Road Safety Audit –Land West of Pagham Road, Pagham, Spine Road

Stage: 1

Site: Proposed spine road with accesses to local centre/care home and school

ATSS Ref: 211206

Appendix B: Key Plan showing Audit Problems

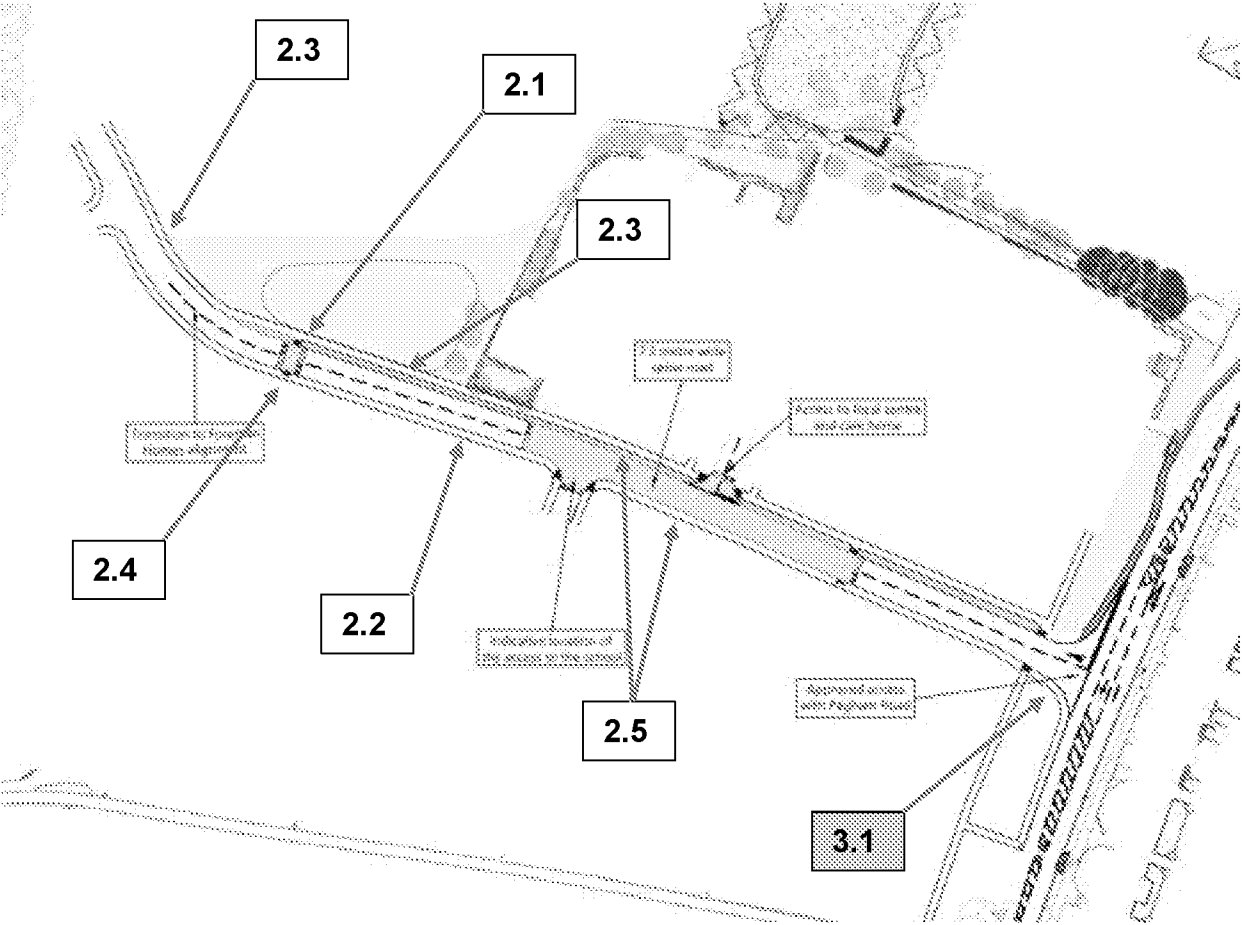
It is not clear if the spine road will be a bus route, however if it is, the proposed speed table is not bus-friendly, as it is not long enough for a bus to completely mount the table before leaving the far side. The resultant motion could cause injury to bus passengers

Recommendation – If the spine road is to be a bus route, extend the speed table to a minimum length of 6.0 metres

The School Keep Clear markings are shown to the east of the school entrance only, meaning that parents' vehicles will legally be able to stop and wait to pick up/drop off students to the immediate west of the entrance. In this position they could obscure pedestrians crossing south to north, such that they would risk being struck by westbound vehicles

Recommendation – Add School Keep Clear markings to west of the school access

It is possible that school parking will extend along the north side of the spine road from the end of the proposed restrictions, over the speed table (which is an informal pedestrian crossing point) and around the inside of the bend. Parked vehicles in this area will obstruct the view to the west of pedestrians waiting to cross north to south on the speed table, such that they would risk being struck by eastbound vehicles

Recommendation – Extend the waiting restrictions westward from the proposed end point, to a point adjacent to the next junction around the bend

It is possible that school parking will extend along the south side of the spine road from the end of the proposed restrictions, over the speed table (which is an informal pedestrian crossing point). If this occurs, pedestrians crossing south to north on the speed table will be obscured by parked vehicles, such that they would risk being struck by westbound vehicles

Recommendation – Provide a short length of waiting restrictions on the south side of the spine road, to protect the speed table/crossing point

SKC restrictions only relate to the carriageway on which they are marked, and so their restriction does not extend to the back of footway in the same way that double yellow lines do. With a smaller upstand of the speed table than a conventional kerb, there is a danger that drivers will park on the footway adjacent to the speed table and parking enforcement would then not be able to take place if vehicles are clear of the SKC. This could cause conflict issues for pedestrians. Furthermore, parking in these areas would only be prohibited during school hours, so vehicles could be parked here overnight and on weekends. To ensure that these areas are legally protected at all times, the double yellow lines would need to be continued through the School Keep Clear markings

Recommendation – Continue the double yellow lines through the School Keep Clear markings
